650L Container Review Issues

10 CFR 71.95 Reportable Items

Titanium Sleeves on Shield Assemblies

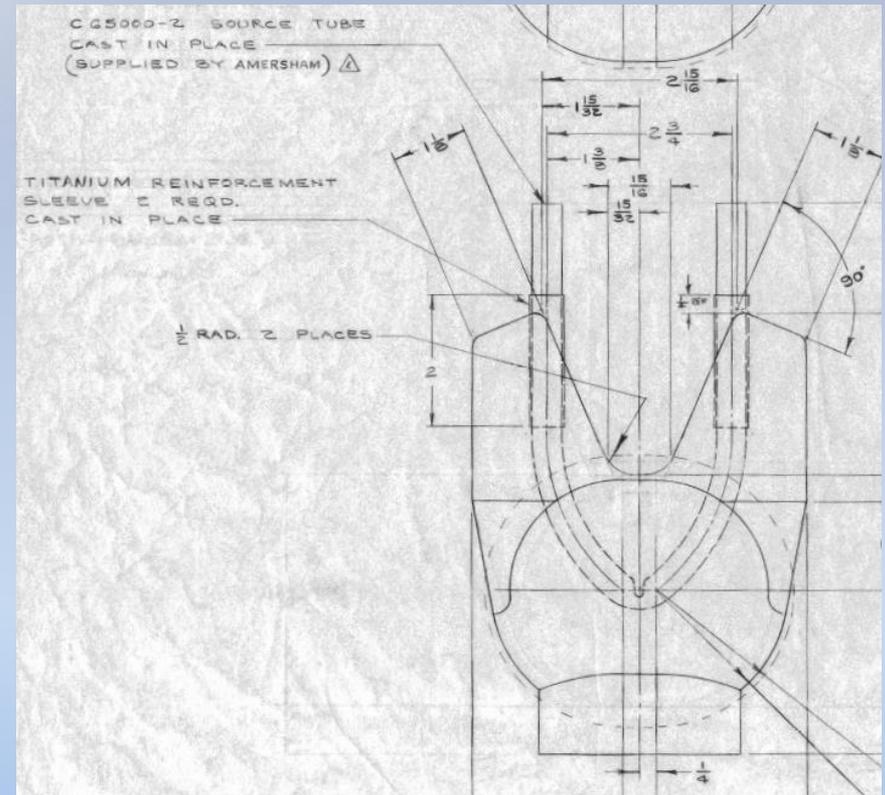
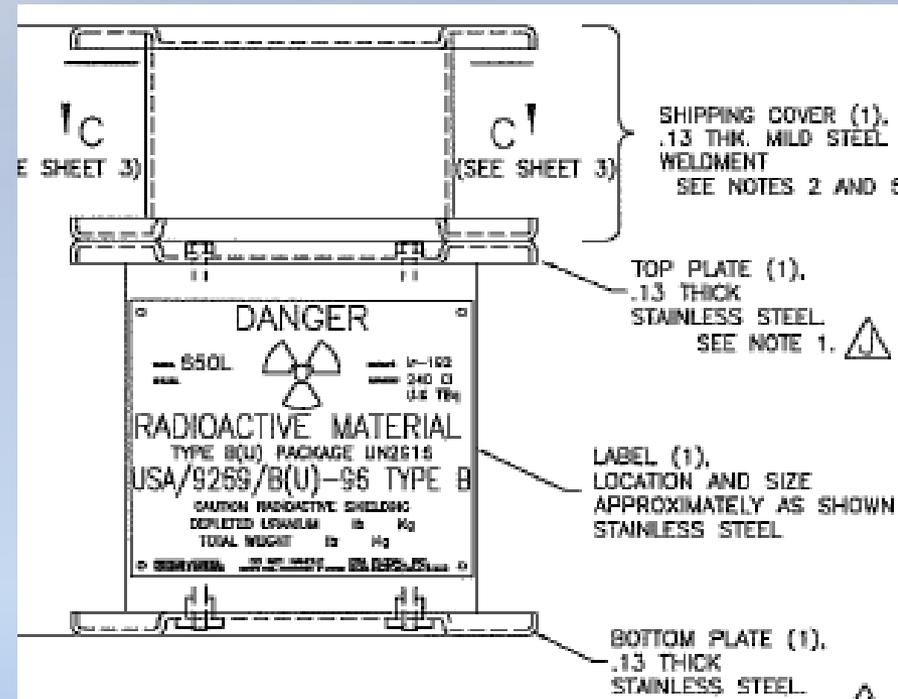
Review of the production drawing from 1979 shows the addition of titanium sleeves on the outside of the titanium source tubes which are then incorporated into the shield after the DU is poured. These sleeves are not currently shown/referenced on the descriptive drawing but are present on all shields used in 650L in transport.

The test units used to demonstrate compliance to transport requirements incorporated these titanium sleeves and since the omission will have no safety significance or adverse impact on the package transport integrity, we request continued shipment of these packages while amendment is processed to update the CoC.

Top and Bottom Plate Flanges - continued

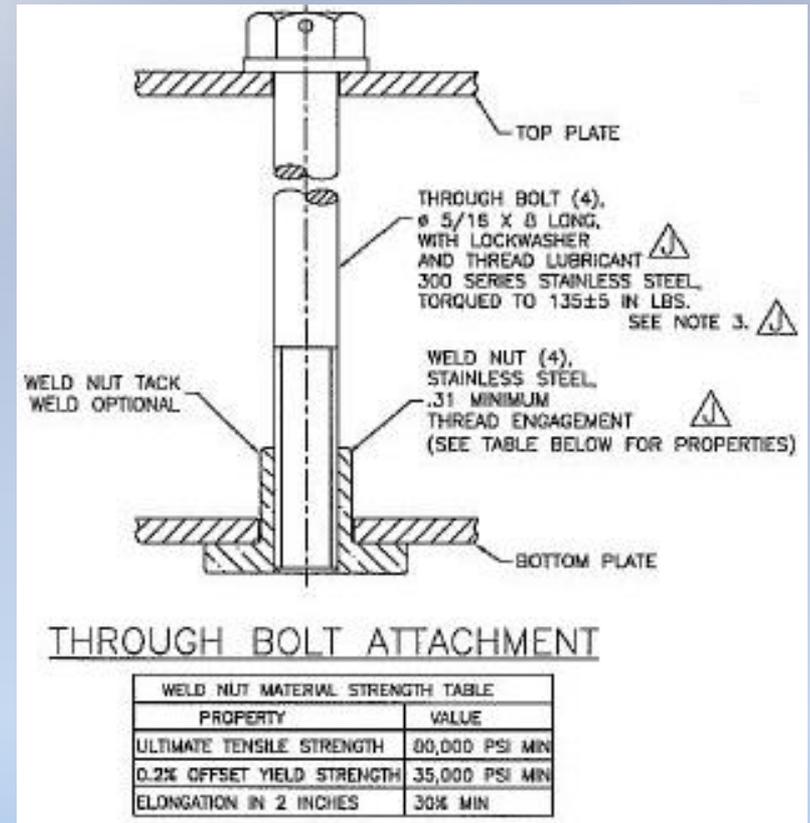
In 2010 a new material requirement was added to the descriptive drawing R65006 Rev J Note 1 which specified the stainless steel used for the top and bottom plates would comply to SAE 30304 per AMS5513.

Inspection records for these components indicate they comply with 304 stainless steel but not to the specific standard on drawing R65005 Rev J.

The test units used to demonstrate compliance to transport requirements were compliant to 304 stainless steel. Materially, 304, 304L and SAE 30304 per AMS5513 materials are all corrosion resistant stainless steels with essentially equivalent material strength and ductility. As such, the components in current use on existing 650L packages are expected to perform identically to components tested for compliance to the normal and accident condition transport requirements. Since there is no safety significance or adverse impact on the package transport integrity, we request continued shipment of these packages while amendment is processed to update the CoC.

Stainless Steel Through Bolts – SCR200- continued

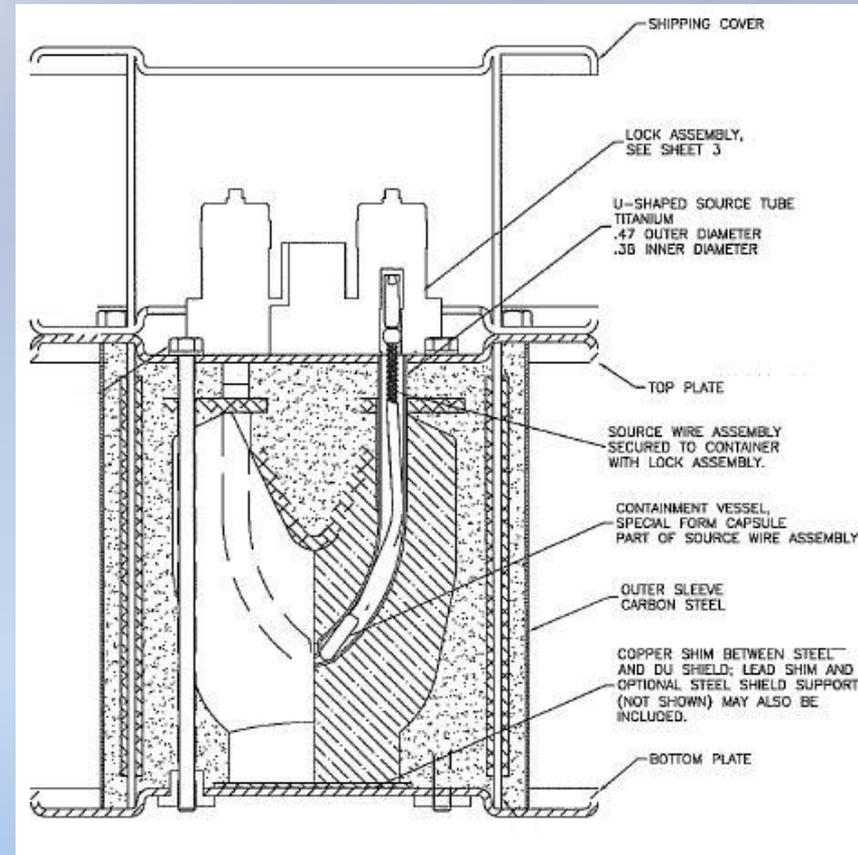
The production drawing specifies this screw as 300 Series stainless steel but does not require material compliance to ASTM F593, Group 1, Condition A. The ASTM standard compliance was added to the drawing in 2010.

Inspection records for these components indicate they comply with 300 Series stainless steel but not to the ASTM standard on drawing R65005 Rev J.

The test units used to demonstrate compliance to transport requirements were compliant to 300 Series stainless steel. The ASTM F593 Group 1 Condition A materials have essentially the same mechanical and corrosion resistance properties as Type 304, 304L and other 300 Series stainless steels.

As such, the components in current use on existing 650L packages and components compliant to the ASTM standard are expected to perform similarly to components tested for compliance to the normal and accident condition transport requirements. Since there is no safety significance or adverse impact on the package transport integrity, we request continued shipment of these packages while amendment is processed to update the CoC.

Outer Sleeve Plating/Painting - continued

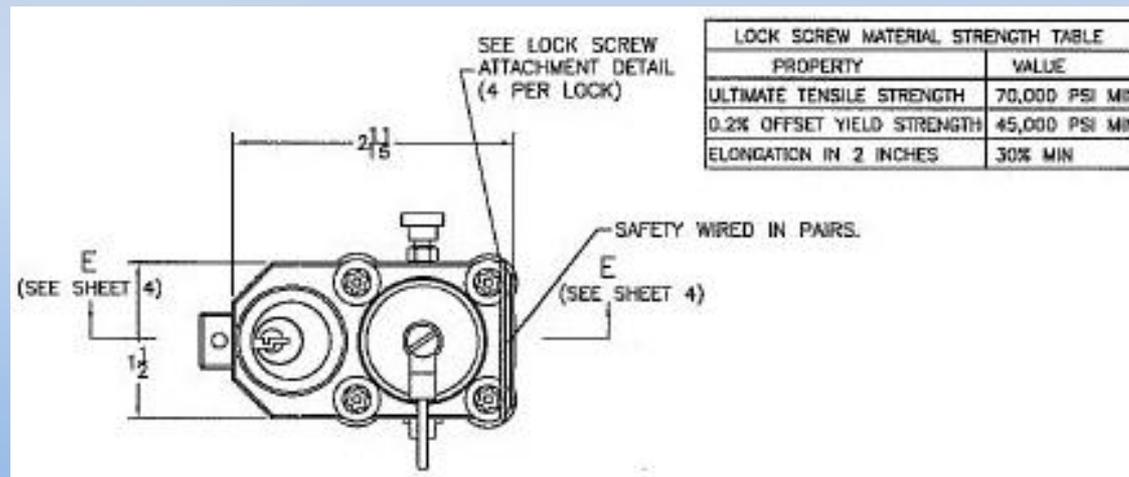
The outer sleeve on drawing R65006 Rev J is specified as “carbon steel”. Review of latest production drawing for this component from 1992 calls for the component to be Zinc Plated, Yellow Chromate and also painted. These surface finish details are not currently specified on drawing R65006.

The addition of zinc plate, yellow chromate and paint on the outer sleeve will have no detrimental or adverse impact on the 650L package ability to comply with the Type B requirements.

All active 650L containers as well as the test units used to demonstrate compliance to transport requirements were included these material requirements.

Continued transport of 650L containers is requested since the units in transport will perform as well as the tested specimens and their continued use will have no adverse impact on the package integrity during transport.

Since there is no safety significance or adverse impact on the package transport integrity, we request continued shipment of these packages while amendment is processed to update the CoC.
